ADDENDUM NO. 1

September 14, 2026

**Perry Meridian High School Phase 2 Renovations
401 W. Meridian School Road
Indianapolis, IN 46217**

C-6.1

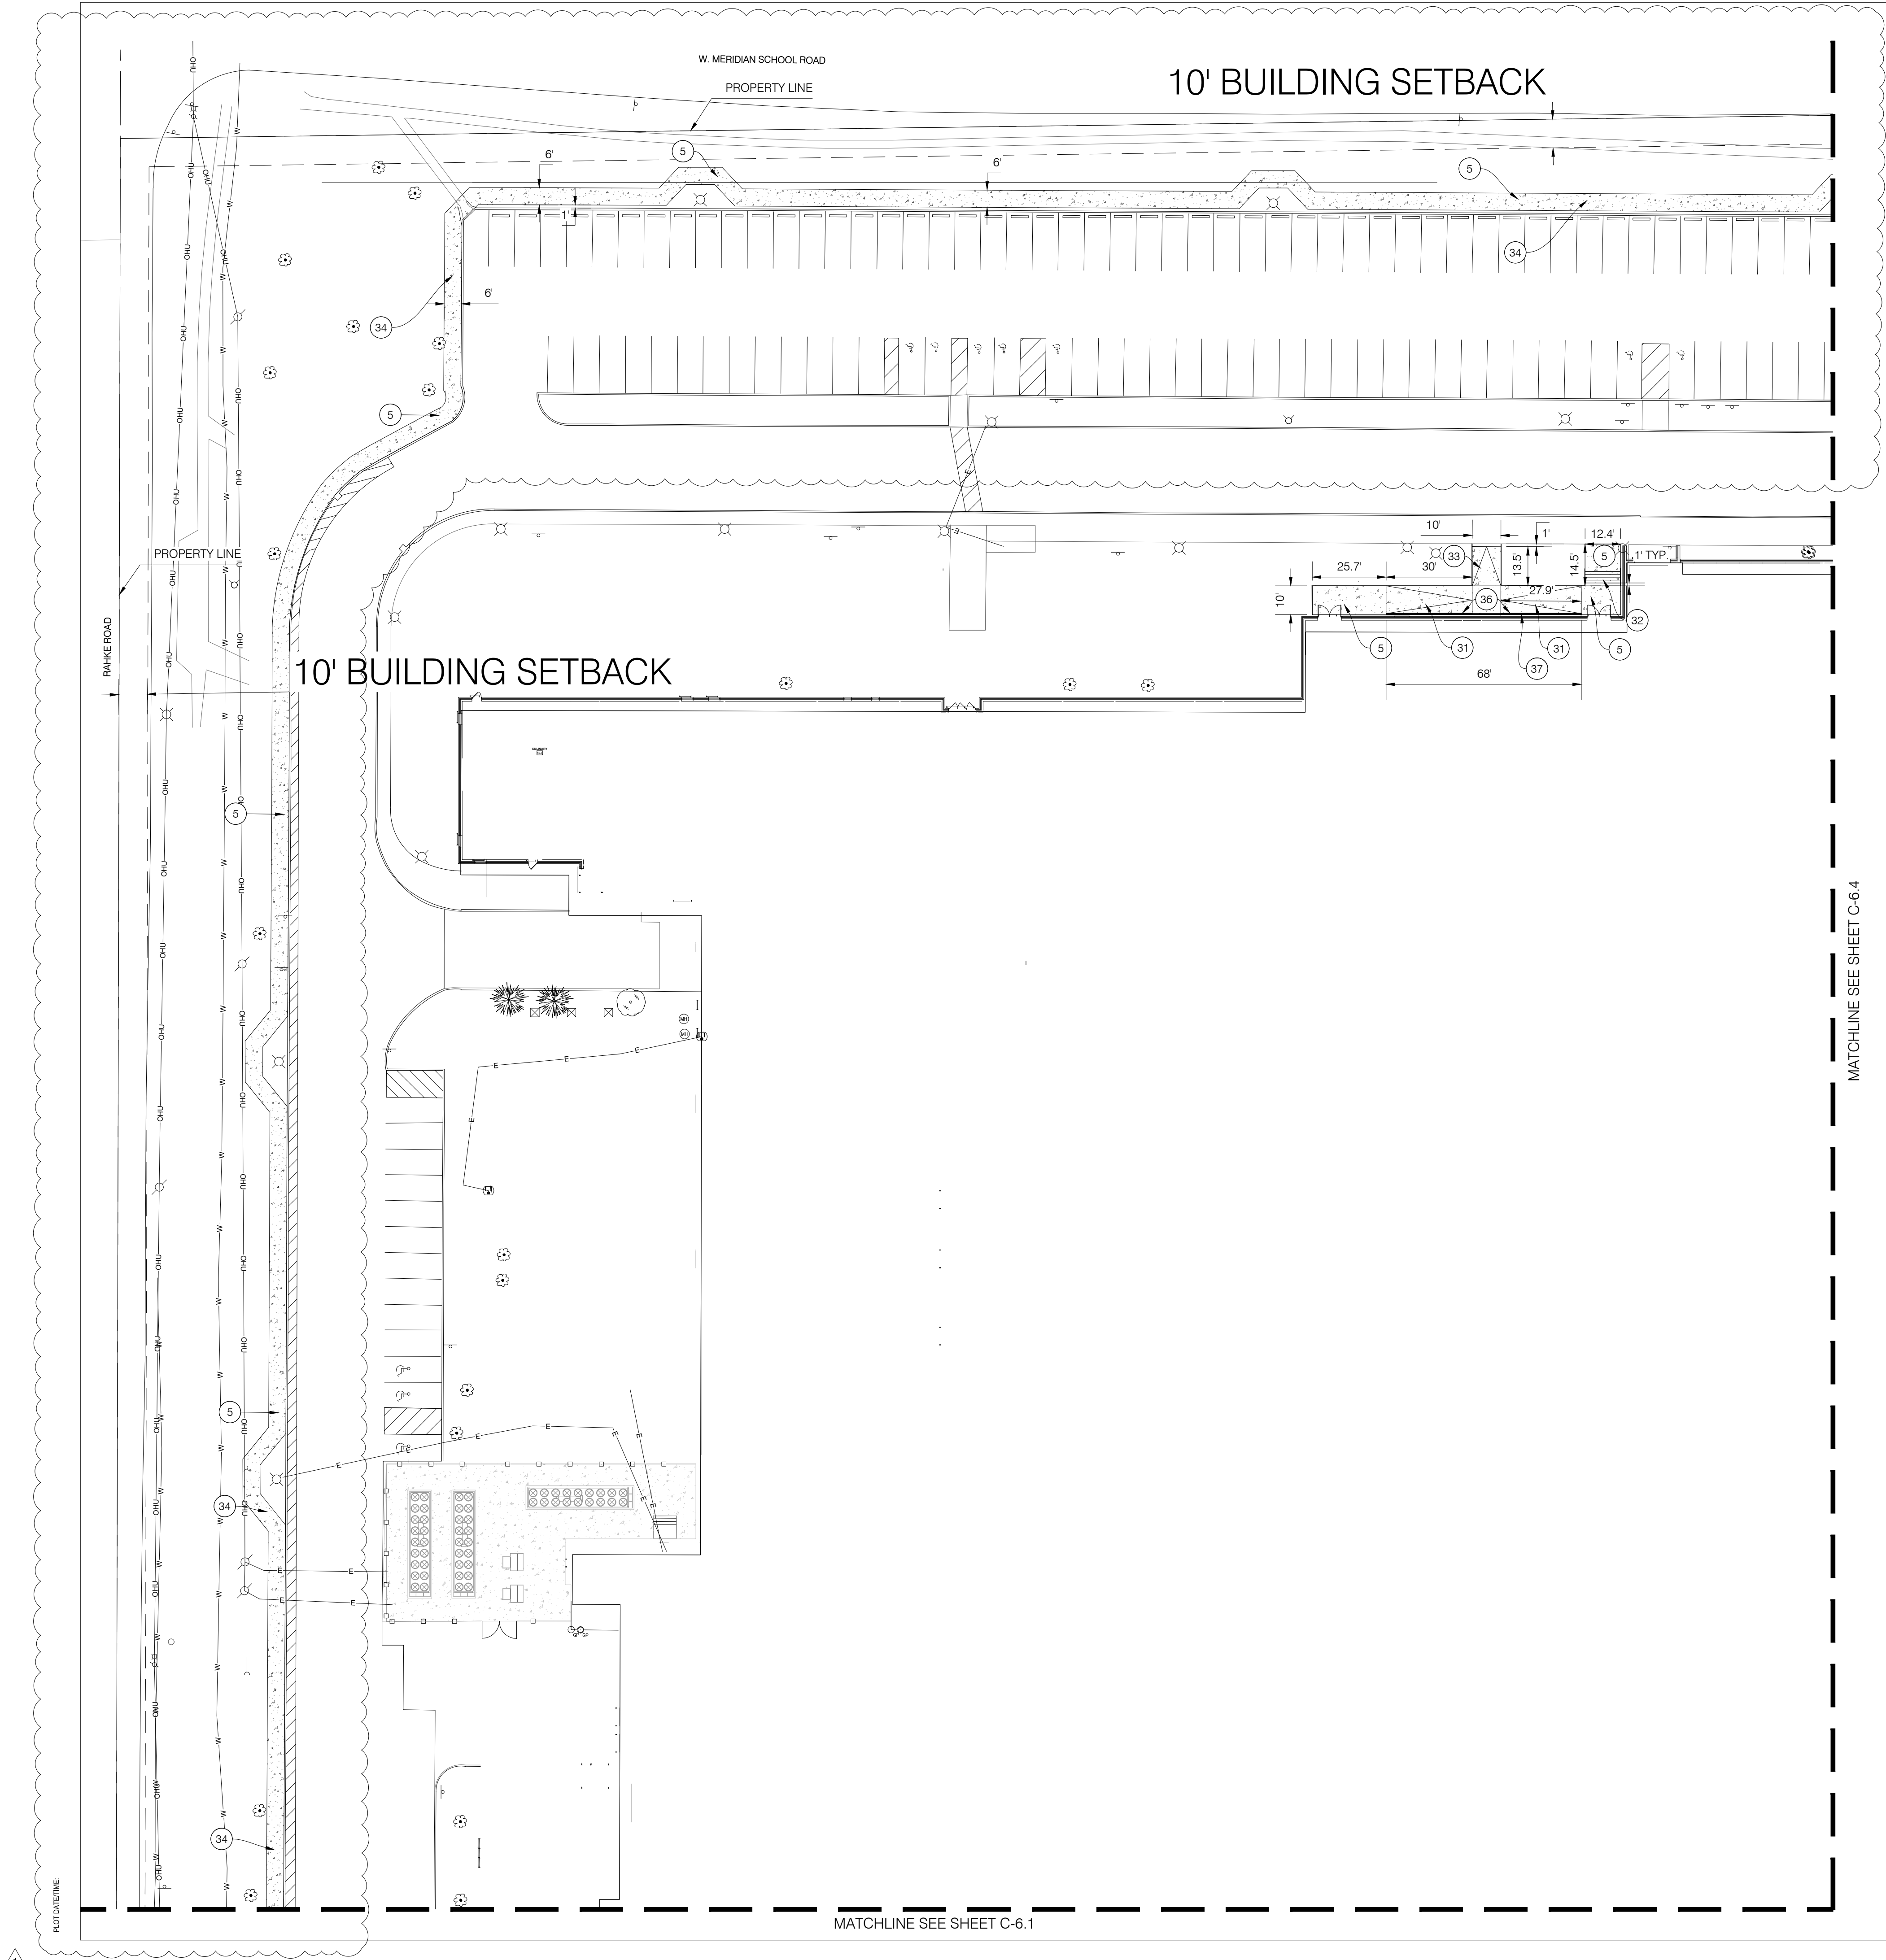
1. Drawing Sheet Number: C-6.1
Drawing Sheet Title: SITE PLAN

Change: "Site Plan Keynotes" pertaining to the sidewalk have been updated/added.
2. Drawing Sheet Number: C-6.3
Drawing Sheet Title: SITE PLAN

- "Site Plan Keynotes" pertaining to the sidewalk have been updated/added.

C-6.4

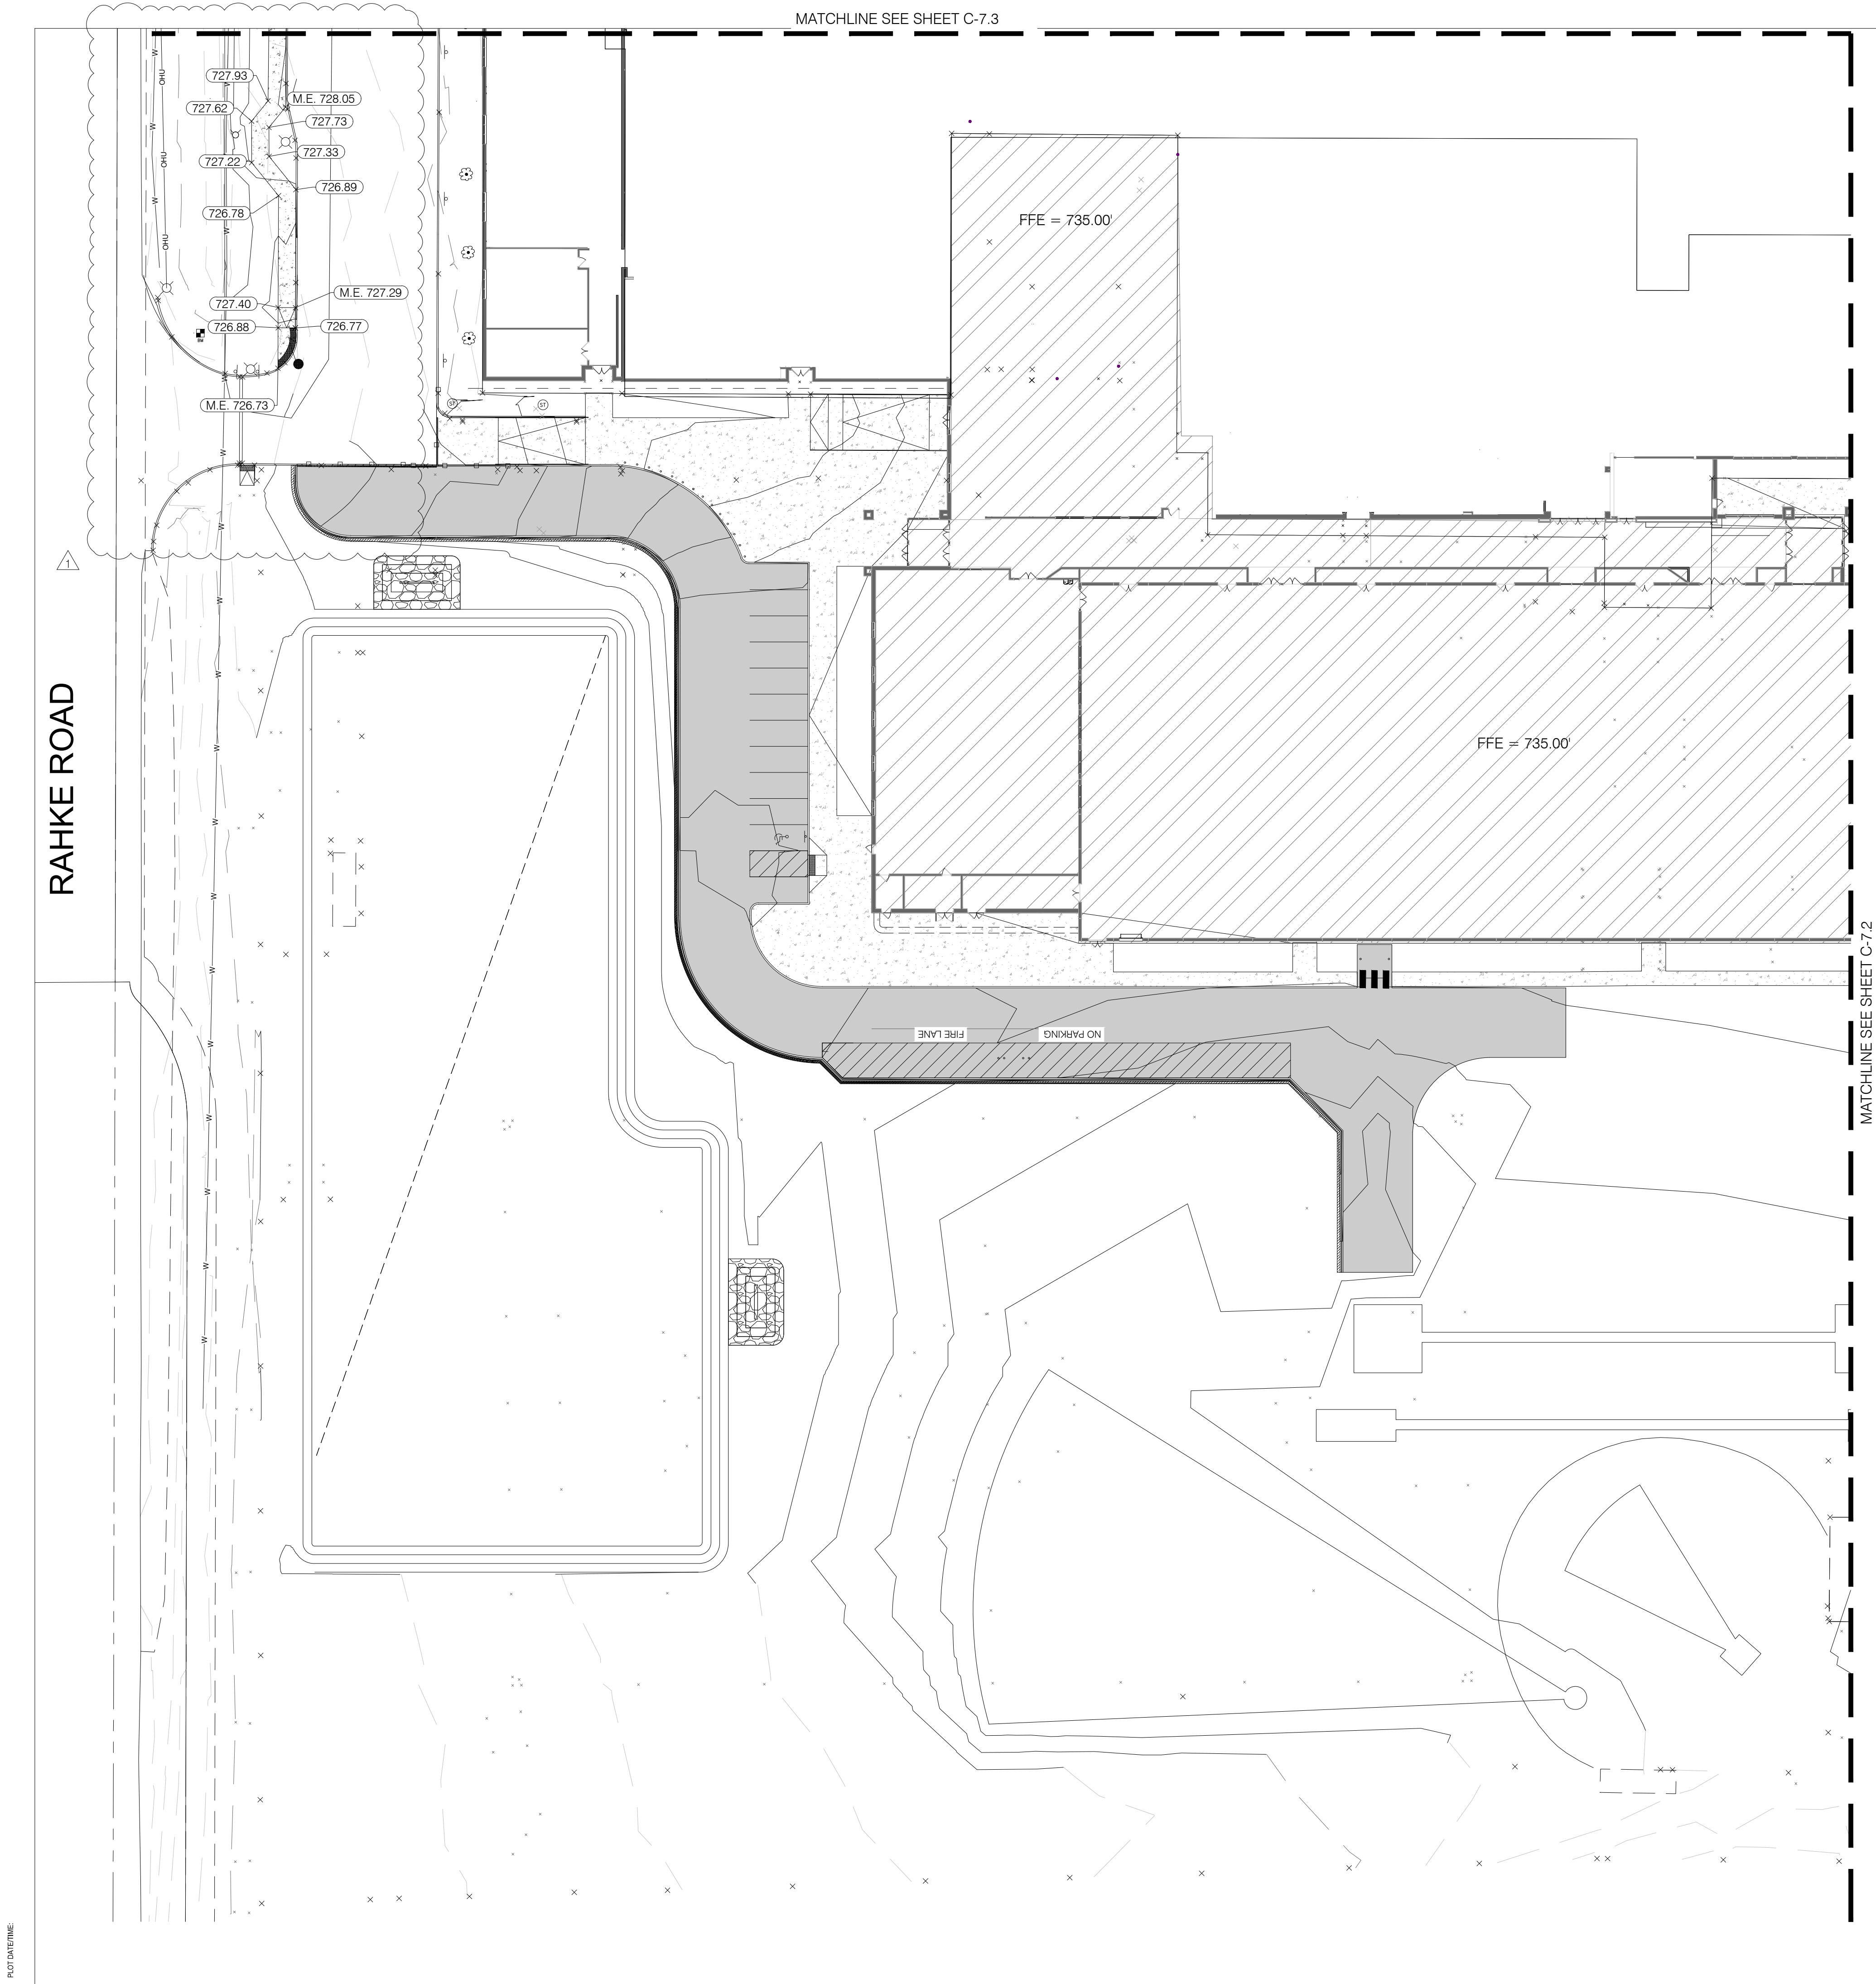
Change: "Site Plan Keynotes" pertaining to the sidewalk have been updated/added.
3. Drawing Sheet Number: C-6.4
Drawing Sheet Title: SITE PLAN

Change: "Site Plan Keynotes" pertaining to the sidewalk have been updated/added.
4. Drawing Sheet Number: C-7.1
Drawing Sheet Title: GRADING PLAN

- "Site Plan Keynotes" pertaining to the sidewalk have been updated/added.

C-7.3

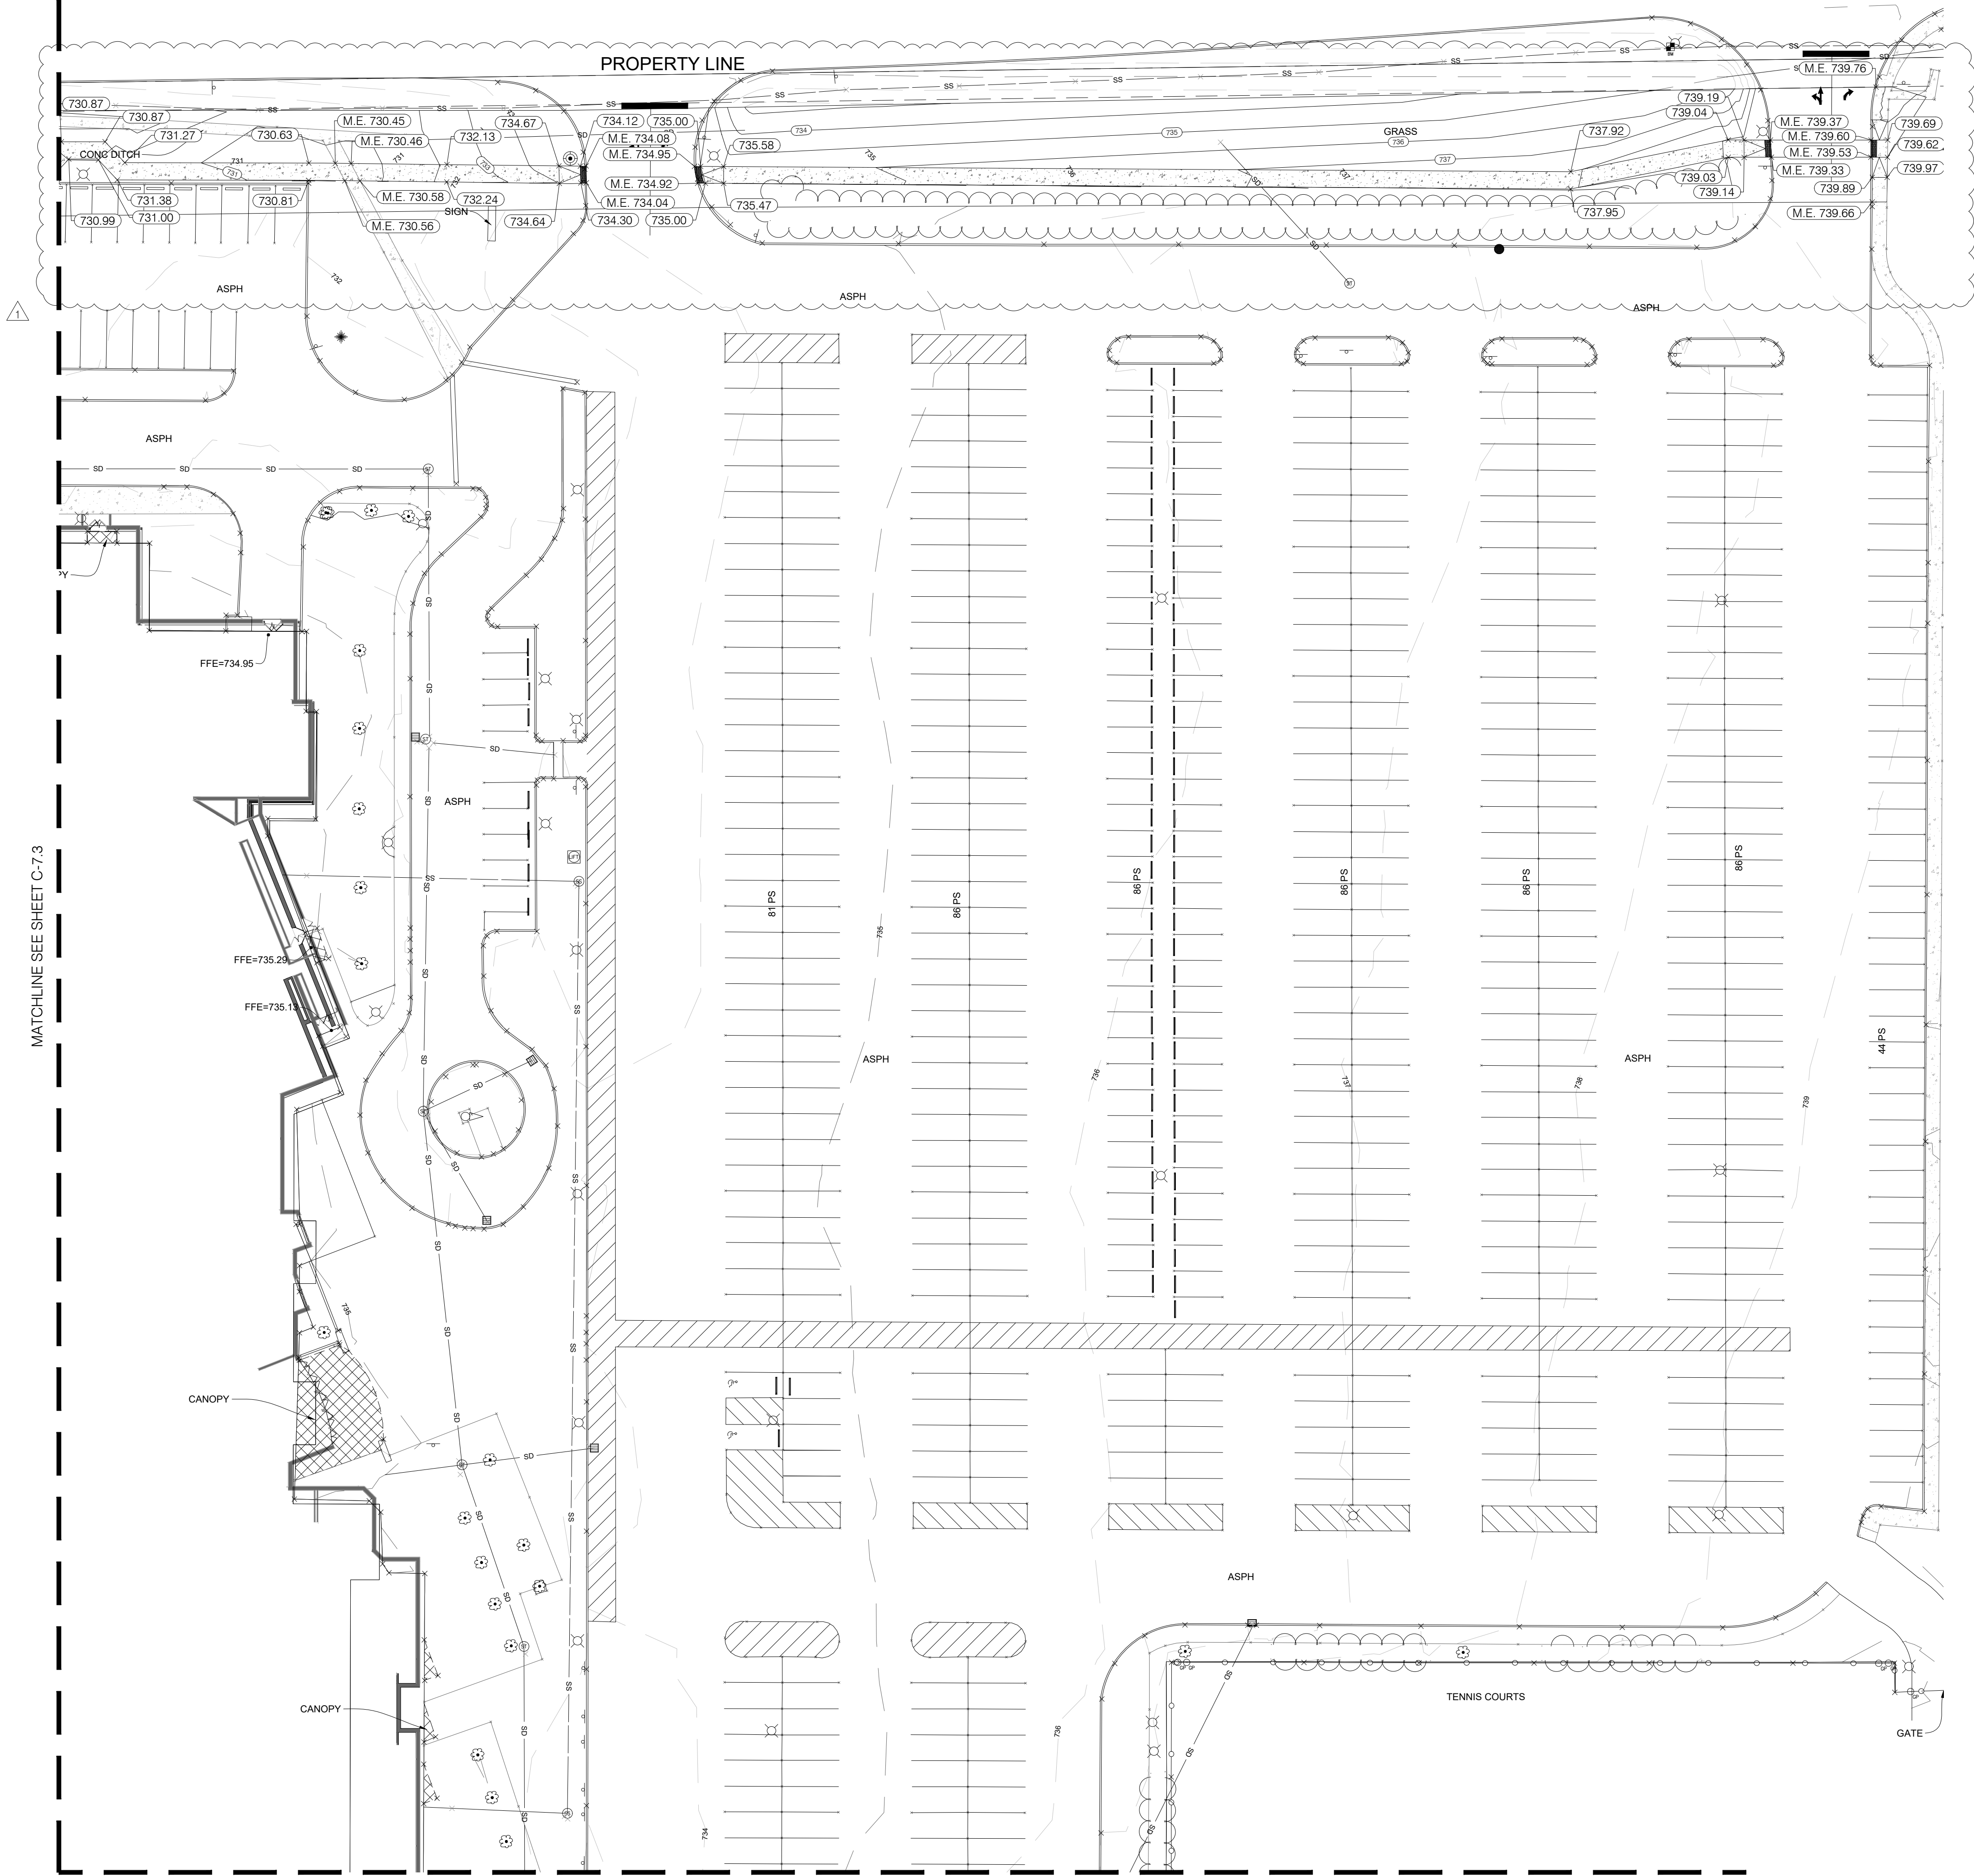
Change: Spot elevations for the proposed sidewalk have been added.
5. Drawing Sheet Number: C-7.3
Drawing Sheet Title: GRADING PLAN

Change: Spot elevations for the proposed sidewalk have been added.
6. Drawing Sheet Number: C-7.4
Drawing Sheet Title: GRADING PLAN

- Spot elevations for the proposed sidewalk have been added.
